LEGEND (ALL CHANGES TO ALL LEVELS)

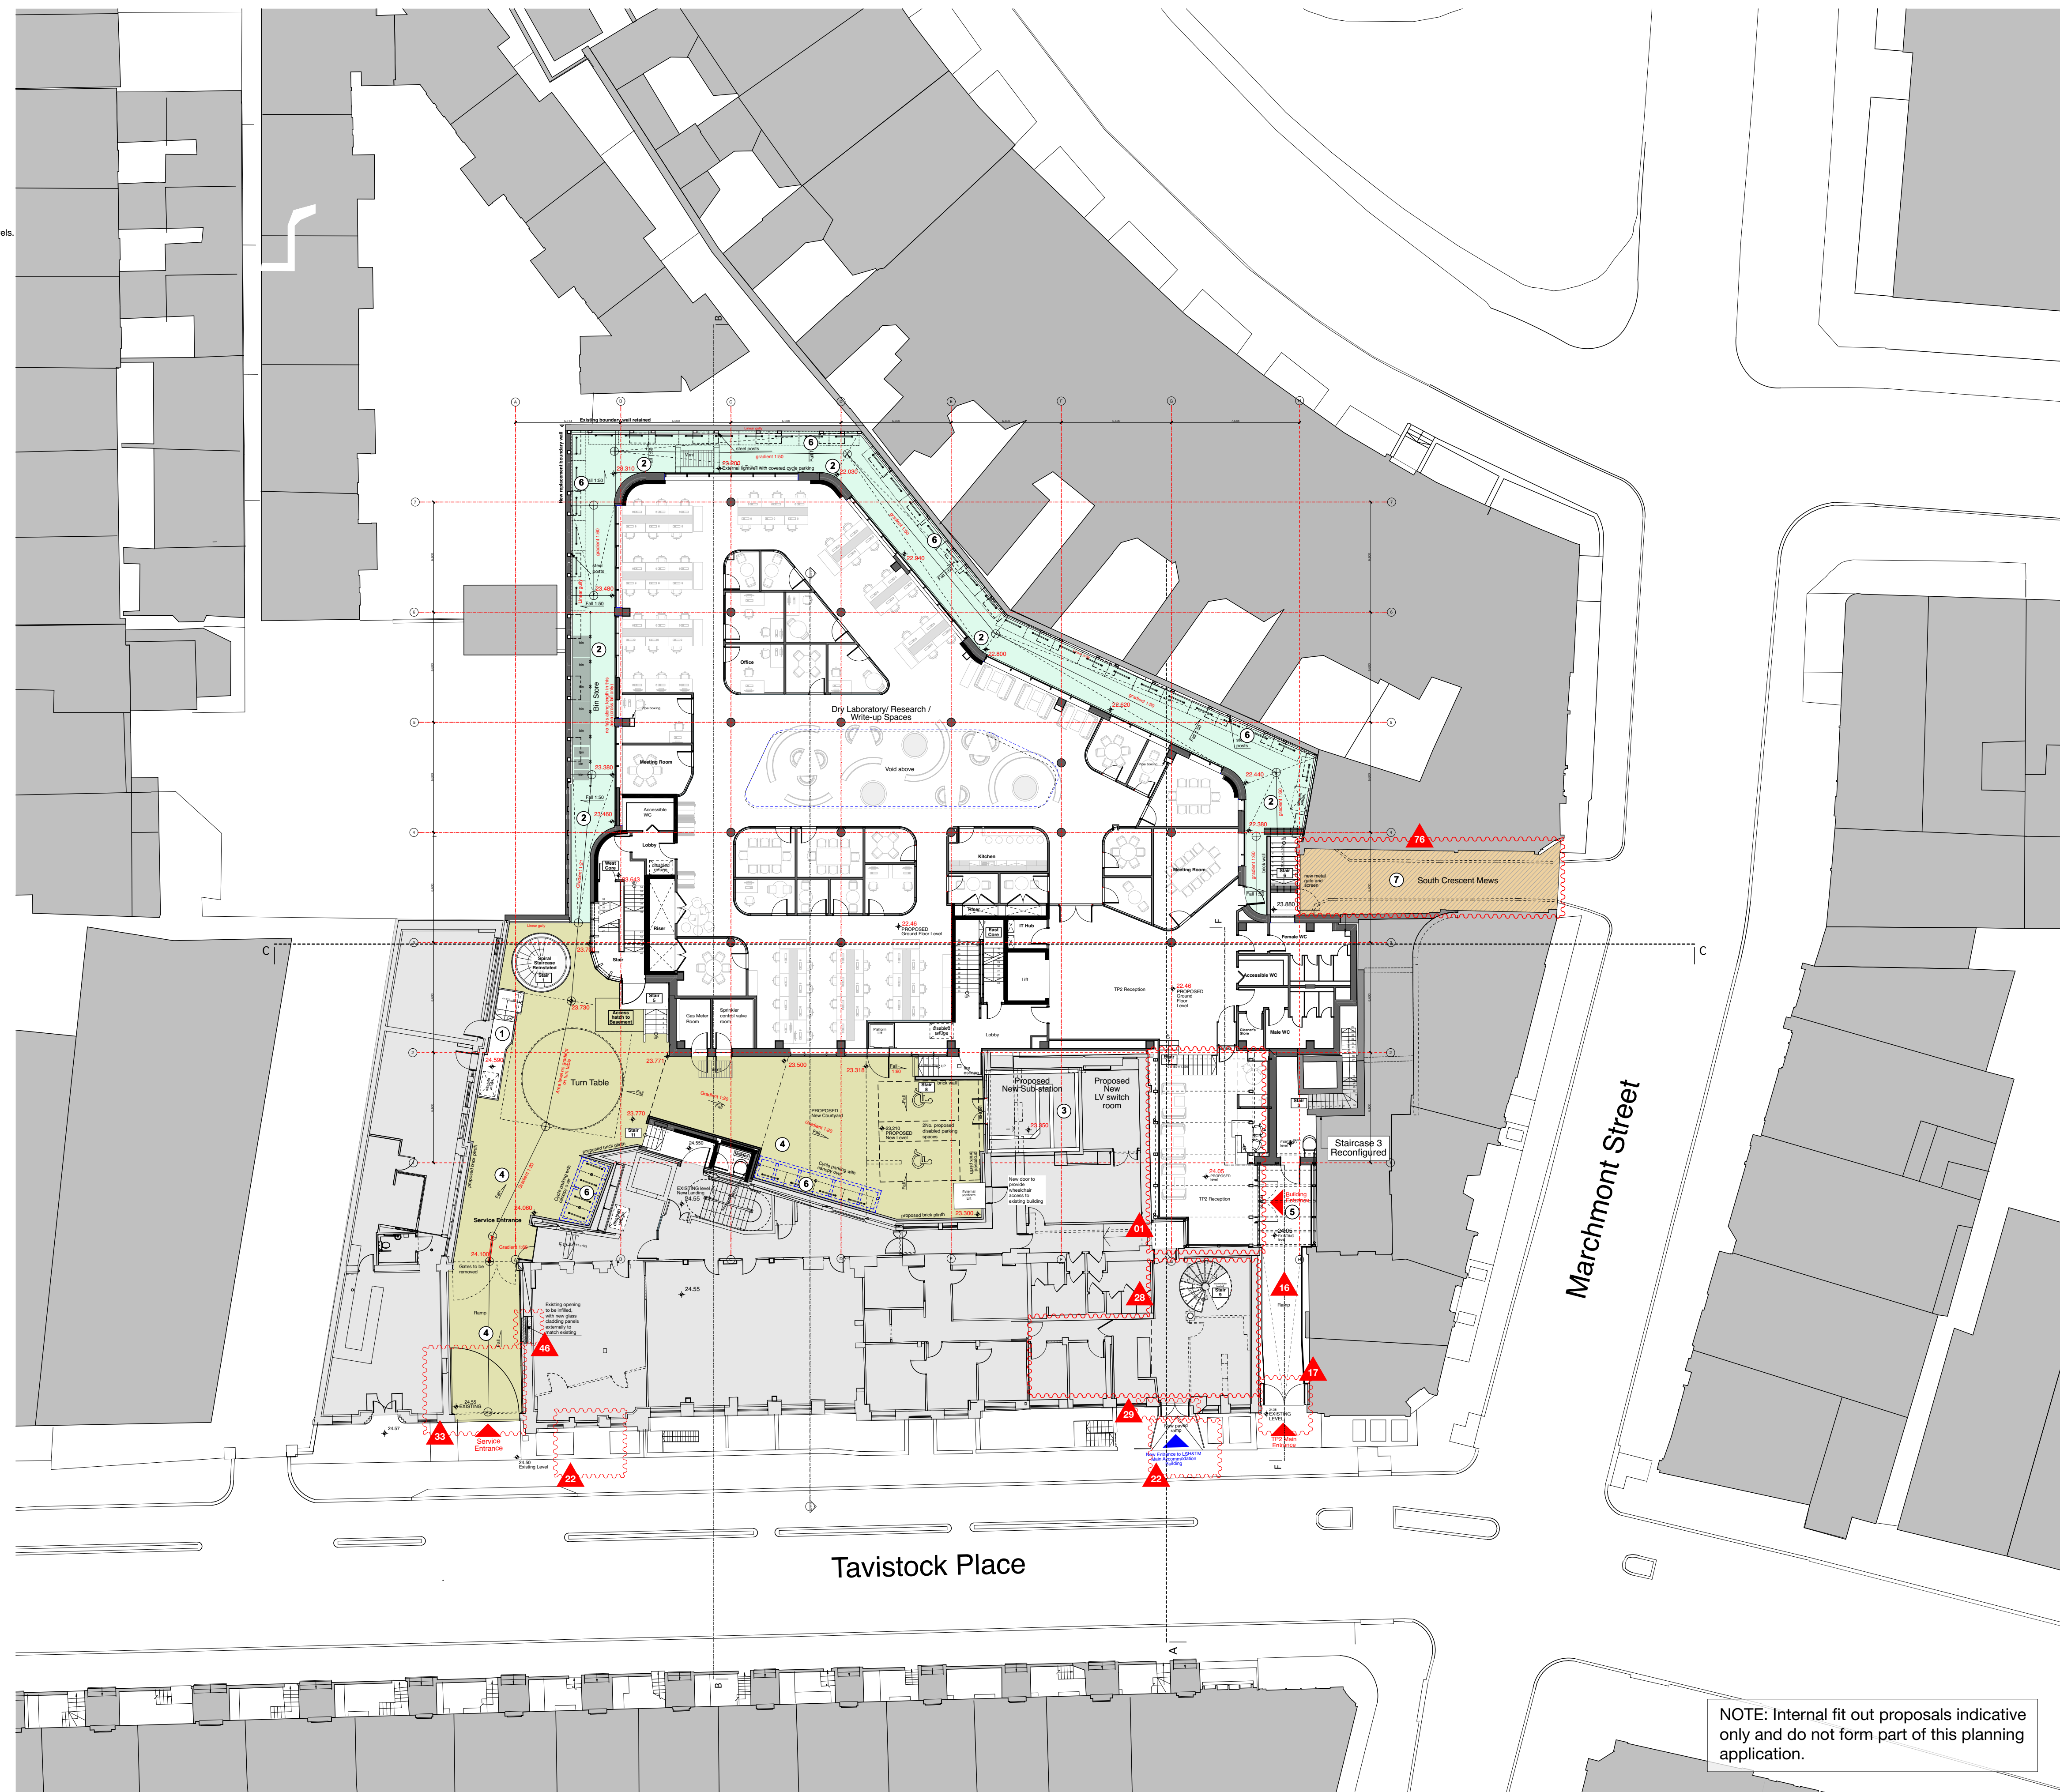
- 01 Stair 2 omitted, and glazed entrance enclosure enlarged
- 02 Window added
- 03 New steps to base of external spiral stair
- 04 Stair 3 roof and gable end arrangement revised.

- 05 Level 3 accommodation mansarded
- 06 Roof light size, height and position adjusted, and smoke vents added.
- 07 Louvres omitted.
- 08 Roof light size, height and position adjusted.

- 09 External ramp adjusted, and railings added.
- 10 West stair core glazing fenestration adjusted to suit amended stair landing levels.
- 11 External paving levels in courtyard raised to achieve required paving falls.

- 12 Low brick plinth added to base of external walls to TP2.
- 13 Brick plinth added to base of existing buildings within courtyard.
- 14 New steps and landing outside room G1.

- 15 Bin store enlarged and repositioned.
- 16 Gallery passageway to TP2: finishes revised.
- 17 Gallery passageway: entrance gates design revised.
- 18 Window on north elevation of TP2 reduced in length.

- 19 Revised turn-table size and position
- 20 Entrance ramp gradient and levels adjusted.
- 21 External levels adjusted
- 22 TP1 west door ramp omitted
- 23 Fall restraint added

- 24 Gates removed
- 25 Maintenance access door added
- 26 Parapet revised
- 27 Roof/wall shape adjusted
- 28 TP1 reception relocated
- 29 Revised door design

- 30 Modifications to windows, doors and facades facing into courtyard.
- 31 Gate details revised
- 32 Revised proposal for bike storage replacing existing bike racks in Dairy shed.

- 33 Gate retained and modified
- 34 Bike canopy detail revised (typical condition highlighted)
- 35 Sub-station doors revised
- 36 Steps adjusted
- 37 Cladding changed to brass finish

- 38 Wall mounted planters revised (typical condition highlighted)
- 39 Steel posts added to boundary wall (typical condition highlighted)
- 40 Height of glazed entrance roof increased to suit required pitch.

- 41 Glazed entrance roof and canopy revised
- 42 New roof guarding to existing flat roof
- 43 Screening fins and cladding added
- 44 Louvres added
- 45 Ramp omitted

- 46 Door removed and infilled
- 47 Access hatch adjusted.
- 48 Depth of green/blue roof build-up adjusted.
- 49 Blue roof incorporated into green roof and gravel margins added.

- 50 Cladding build-up adjusted
- 51 Orientation of brass seams adjusted
- 52 Roof gutters revised.
- 53 Means of escape revisited and exit door added to TP1

- 54 Spiral staircase landings added at each floor
- 55 Door modified
- 56 Basement louvers to external metal staircase landings
- 57 Revised proposal for mean of escape in TP1

- 58 Revised proposal for window and door
- 59 Revised proposal for door to be left as current
- 60 Gate to be removed
- 61 Capping width adjusted and roof planters shown indicatively.

- 62 Door to be replaced
- 63 Revised proposal for the entrance
- 64 Gates and Entrance door in TP1 to be replaced
- 65 Existing stair to be demolished
- 67 Existing window and door to be replaced

- 68 New reconfiguration for new spiral stair and WC
- 69 Staircase partially demolished
- 70 Level adjusted
- 71 Lift pit adjusted
- 72 Level updated
- 73 Red line extended to include South Crescent Mews

- 74 Red line extended to include new ramp and frontage
- 75 Ladder added
- 76 Works to Mews paving/kerbs added
- 77 Minor adjustment to ridge, and eaves line, (not affecting ridge level noted on consented drawings).
